OOPS WE GOOFED!

~~CORRECTIONS VOLUME III pg 33~~

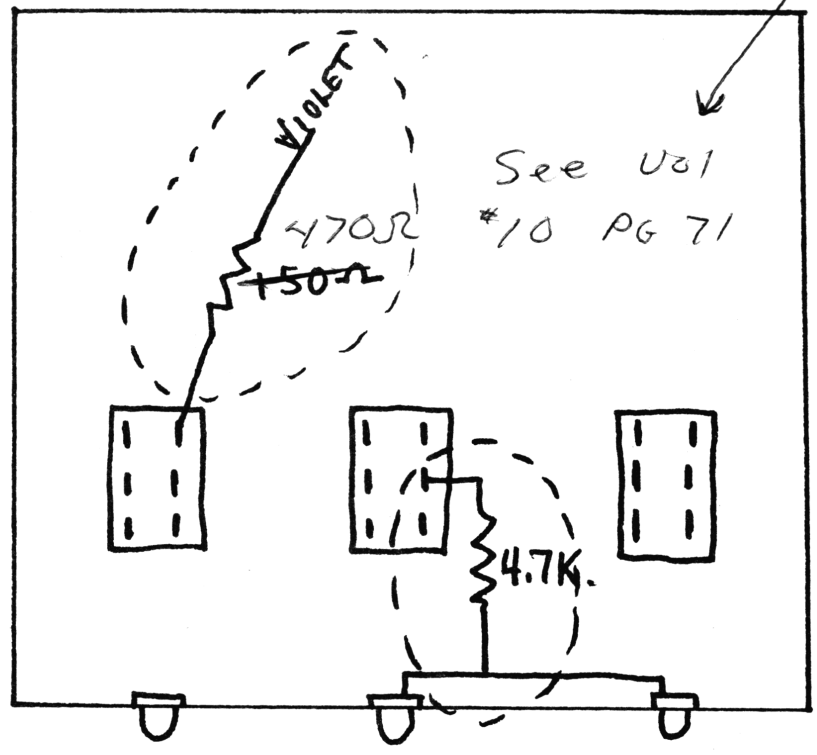
--- → DENOTES AREA TO BE CORRECTED
